**LEMON CREEK RANCH PHASE 1A WATER AND SEWER**  
**Solicitation Number: CO-00494**  
**Job Nos.: 21-1037 and 21-1531**

**ADDENDUM 1**  
**October 28, 2021**

SHEET NUMBER  
**C8.4**

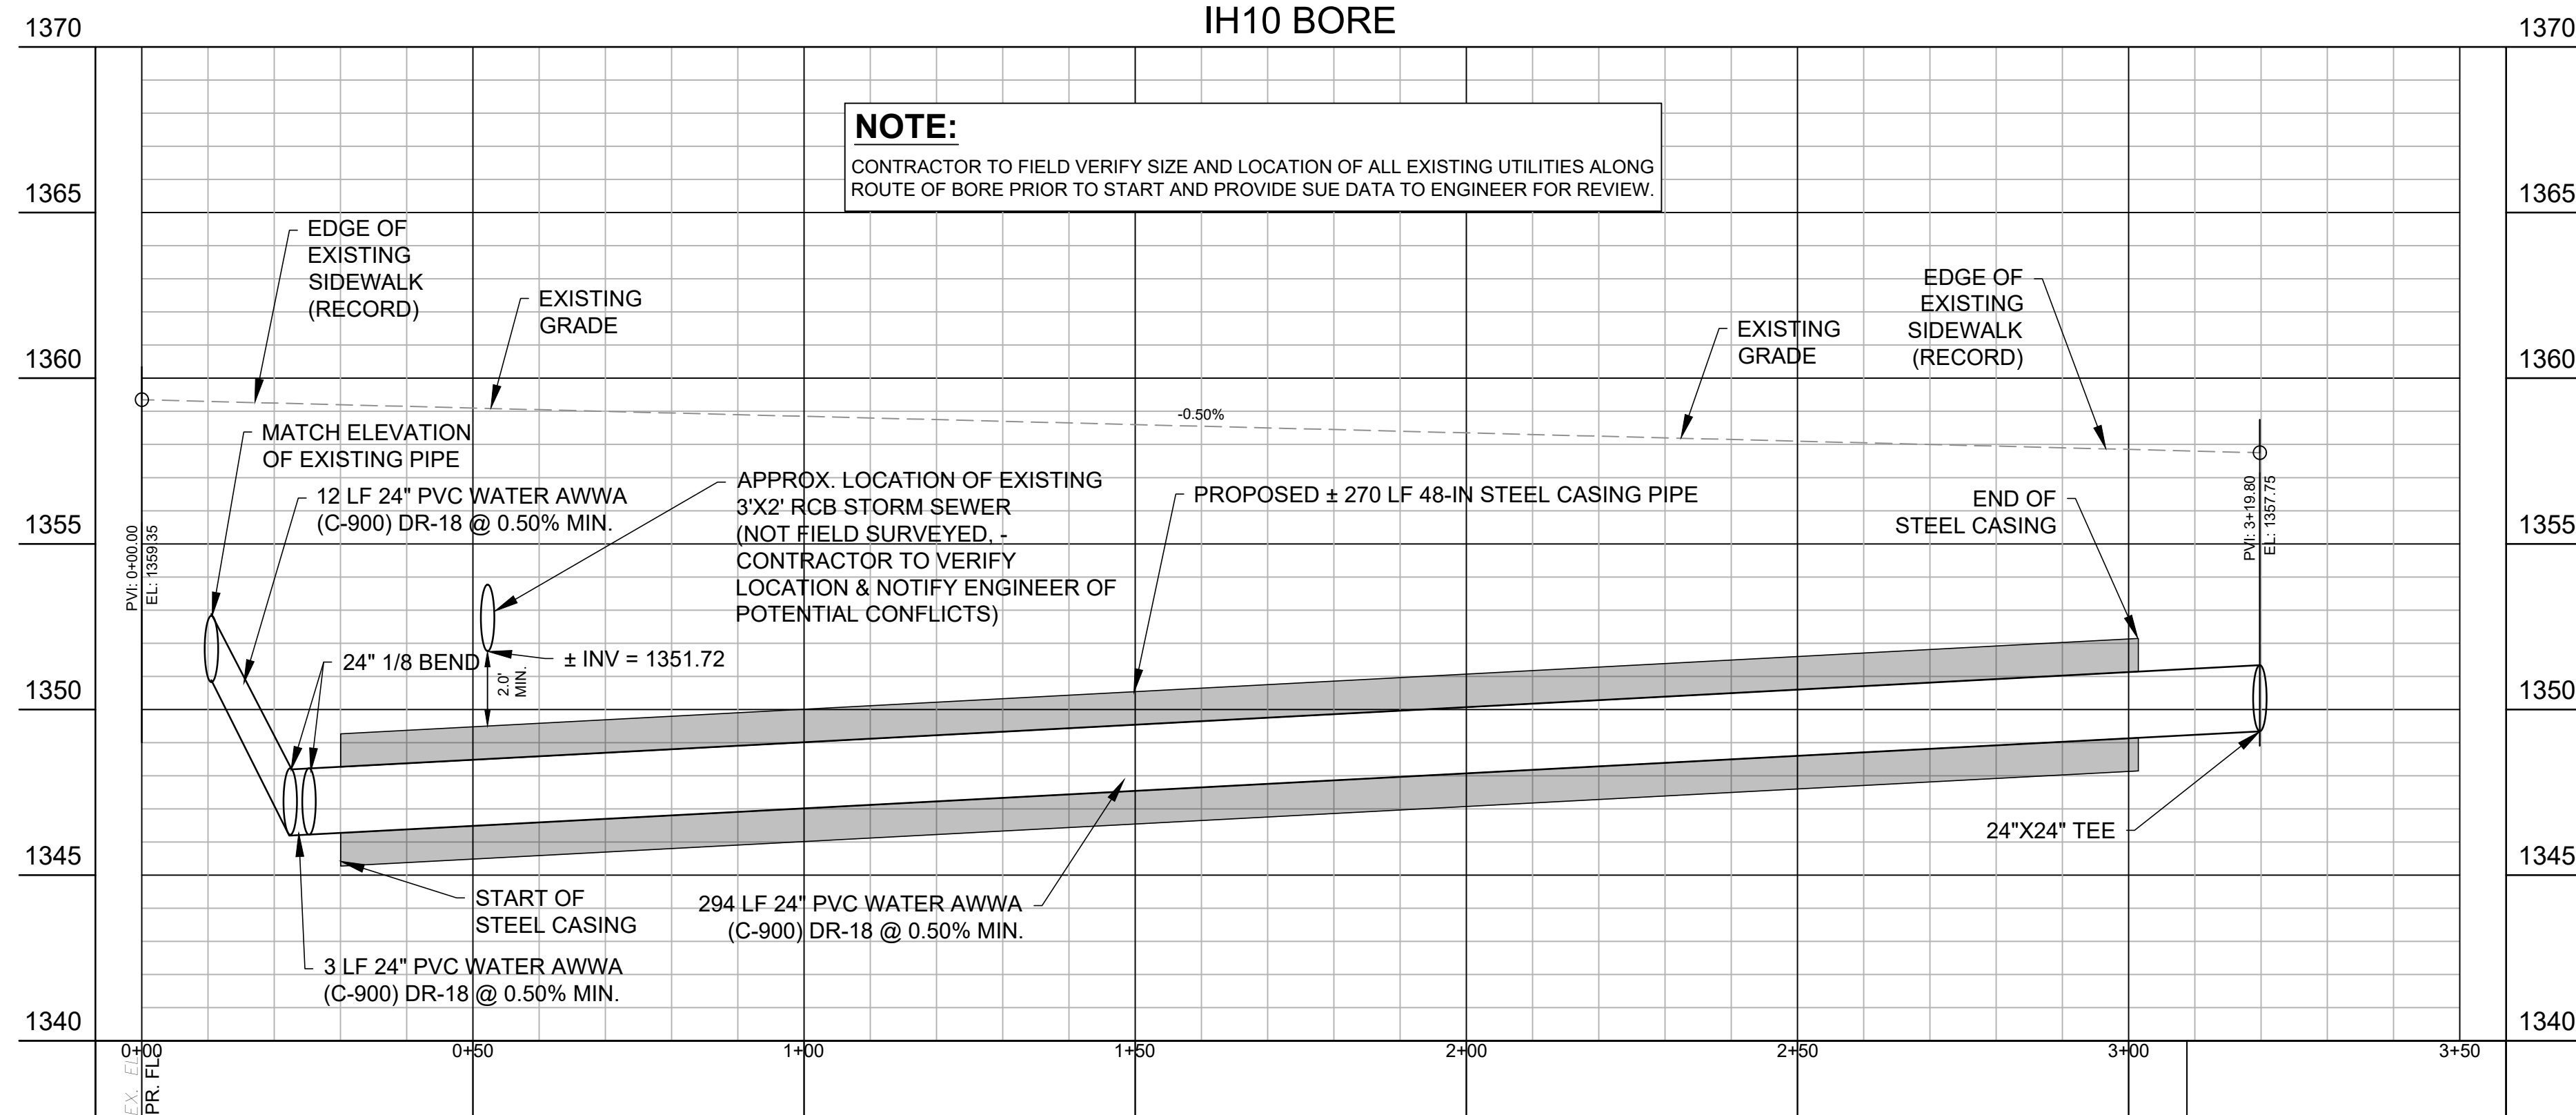
- 3. Question: Bore for the waterline plans does not show existing storm drain that is shown on sewer plans and this bore will be in conflict with storm since it is shown at elevation 1350, this bore needs to be lowered and extended to sta 3+19.**  
*Response: See the attached, revised sheet C8.4 with the water bore lowered in order to avoid a potential conflict with the existing storm drain (see “Changes to the Plans” No. 1 below).*

- 1. Remove sheet C8.4 and replace with the revised version attached to this Addendum. The bore depth for the water has been lowered in order to avoid a potential conflict with the existing storm drain.**
